EXHIBIT 1 - STAFF REPORT

DATE: May 15, 2018
TO: Historic Landmarks Committee Members
FROM: Chuck Darnell, Associate Planner
SUBJECT: HL 3-18 / DDR 2-18 – 608 NE 3rd Street

This is the consideration of a Certificate of Approval for exterior alterations to a historic landmark located at 608 NE 3rd Street. The subject property is listed on the McMinnville Historic Resources Inventory as a Distinctive resource, and is also classified as a secondary significant contributing property in the Downtown Historic District that is listed on the National Register of Historic Places.

Photos of the existing second story entry and a rendering of the proposed second story entry are provided below:

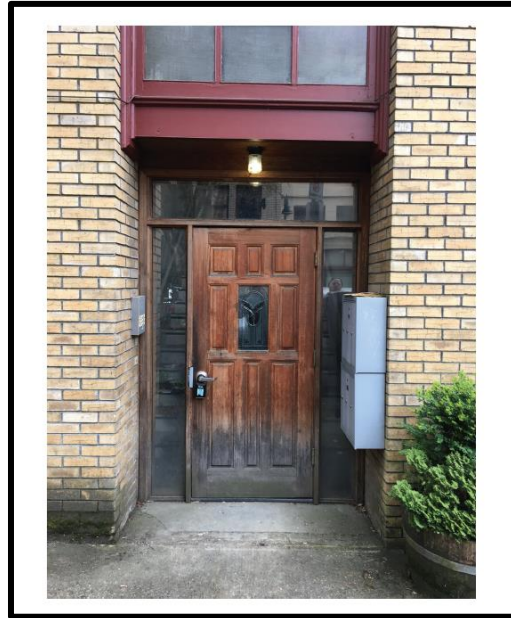
The proposed uses of the building do result in the need to provide adequate access to and egress from the spaces. To achieve this and meet building code requirements, the applicant is proposing to further recess the entryway to the second story residential units by an additional 1'3" to allow for the door to not open into the public right-of-way and pedestrian pathway. The existing door is weathered and not wide enough to accommodate ADA access into the residential units. Therefore, the applicant is proposing to replace the existing door with a wider door that provides ADA accessibility through the opening. The interior renovations include the addition of an elevator to provide access to the second story and basement, so the applicant wants to ensure that full ADA accessibility can be achieved. The addition of a wider door will result in the removal of one side light. The entry will retain one of the two existing sidelights and the transom above the door. The additional recess of the entryway will also allow for seismic upgrades to occur with a steel column wrap around the entryway. This steel column wrap feature is proposed to be visible on the interior of the recessed entry, and will cover some of what is currently buff colored brick. The applicant is proposing to carefully mine out the buff colored brick that would be covered, and use that to replace other exterior brick on the north and west facades that is so spalled or cracked that they require replacement. Because steel is not an existing building material on the historic building, a condition of approval has been included to require that the steel structural support within the

recessed entryway be wrapped in a wooden encasement or trim consistent with the existing wood trim on the ground floor of the building and surrounding the other entryway on the north façade of the building. A condition of approval has also been included to require that the replacement door providing access to the second story be wood to be consistent with the original building materials on the ground floor of the building.

3. That the replacement door providing access to the second story be wood to be consistent with the original building materials on the ground floor of the building. The final details of the replacement door shall be reviewed and approved by the Planning Director prior to installation.

A rendering and elevation drawing showing the awning depth and design are provided below:

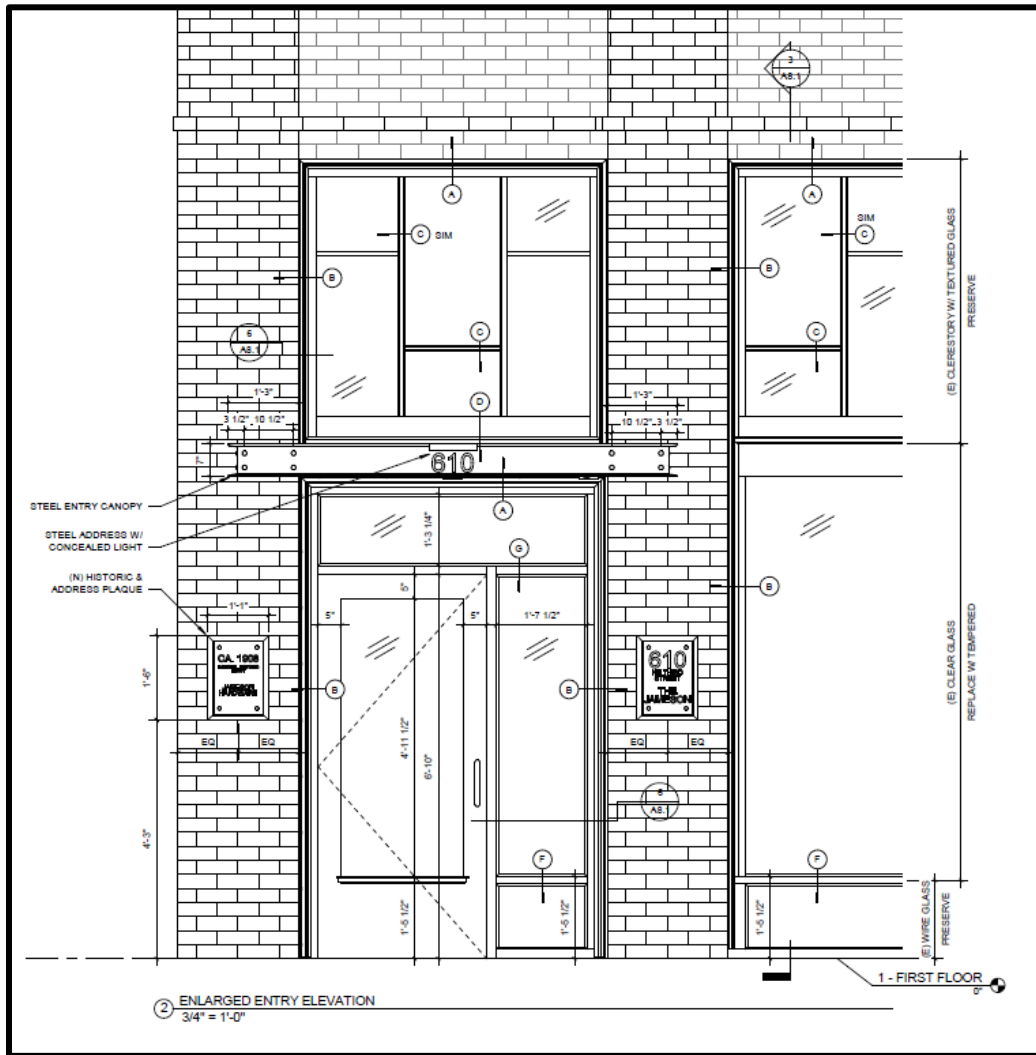
The canopy will project from the 5'-6" wide recess between the two flanking columns. In order to provide more protection at the entrance, the canopy, once over the sidewalk expands to 8'-0" wide by extending fifteen inches over the two, twenty six inch wide columns. The column can still be seen extending from the ground to the second story. Findings to support the design waiver and allow for the canopy to extend over a portion of the flanking columns are provided below.

The applicant has provided an argument that the demonstrable difficulty in meeting the code requirements for the steel awning are relative to the seismic upgrade. The Taylor-Dale building is an unreinforced masonry building and most of the steel added for the seismic upgrade will be added within the interior. The entrance to the second story will be an exception. Half inch steel plates are proposed to strengthen and contain the brick columns flanking the entrance. The steel plate was proposed to be visible on the exterior within the second story entry recess. However, as part of the Certificate of
